**CITY OF SNELLVILLE
DEPARTMENT OF PLANNING & DEVELOPMENT
MAYOR AND COUNCIL**

CASE NUMBER: #CUP 18-03

REQUEST: Request for Conditional Use Permit for a Retail Automotive Parts Store and Request for Variances

DEVELOPMENT/PROJECT: O'Reilly Auto Parts Store

The proposed site plan, submitted by the applicant.

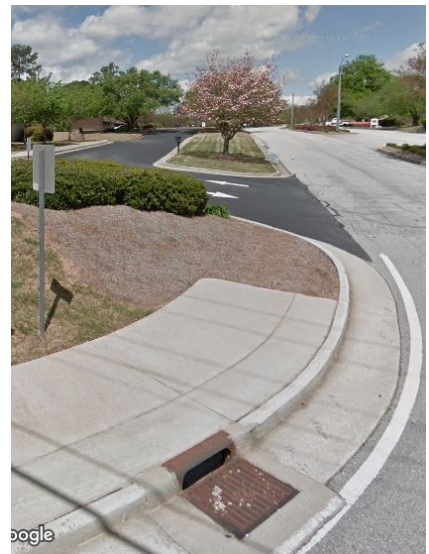
The concept plan shows the front parking lot, beginning at and running parallel to the front property line with a concrete retaining wall and fence beginning midway and running west to the western front corner of the property. Although there is a large sodded area located between the front parking row/retaining wall and public sidewalk, this area is within the public right-of-way and not part of the front landscape strip.

The concept plan accurately depicts the location of the 10 foot required front landscape strip. Shifting or reducing the building footprint will allow implementation of the front landscape strip for the planning of trees and shrubbery which will help to create a more aesthetically pleasing visual quality from the W. Main Street perspective. The Planning Department recommends denial of this request.

The applicant is requesting waiver from the requirement to install a pedestrian sidewalk along Fountain Drive due to the lack of an existing sidewalk along Fountain Drive for them to tie into. The Planning Department does not support this request as there are no physical features on the corner property that present a hardship that would make installation not feasible.

The concept plan shows 24 parking spaces in front of the building and 15 parking spaces on the corner side of the building, with no parking in the side or rear of the building. As shown on the concept plan, there are a total of 39 parking spaces, requiring no more than 8 spaces be located in front of the building and no more than 8 spaces be located to the side of the building, with the remaining 23 spaces to be located behind the building. Relocating the building closer to the front and corner side would achieve greater compliance with this requirement.

The concept plan also shows the addition of a full-access curb cut on Fountain Drive. Currently there are two existing curb cuts at each end of the property along Fountain Drive, with the northern curb cut remaining for possible future development. The southernmost existing curb cut may need to be relocated so that it sits back at least 125 feet from the Fountain Drive and W. Main Street intersection.

- a) 10 feet wide front landscape strip.
- b) Concrete sidewalk along Fountain Drive.
- c) A slightly larger building footprint (now 7,639 sq. ft.) for exemption of the requirement that no more than twenty-percent of the parking may be located in front of the building or to the sides or the building.
- d) Conversion of the existing southernmost full-access drive on Fountain Drive to a right-in/right-out drive.
